ADDENDUM NO. 4

Subject: **ITT Invitation to Tender No. F5211-180783**

Title: **Harbour Revitalization in Malbay St George, Quebec**

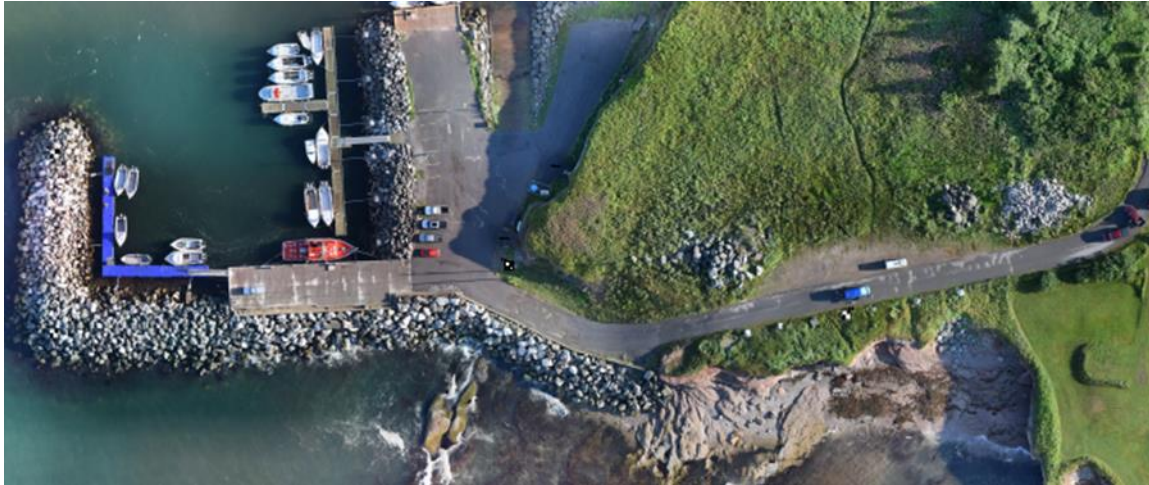
Question #3 :

Is it possible to have a sketch showing the approximate location of the on site stone available for the Contractor?

Answer # 3:

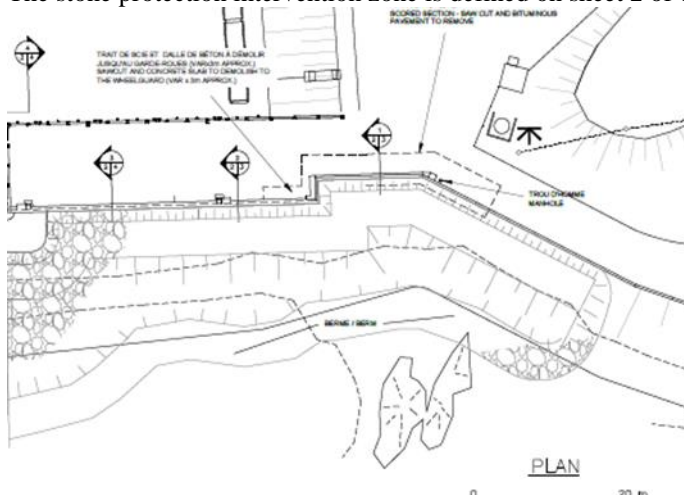
Question #14 :

In Section # 2 of sheet 3/6, the steel plate will be fixed on a wooden wall. The wall does not seem to be open face, so it may be impossible to access the other side of the wall to secure the anchors. Do you have a specific method in place?

Answer # 14:

The plates shall only be supported and the different layers of stone will retain them
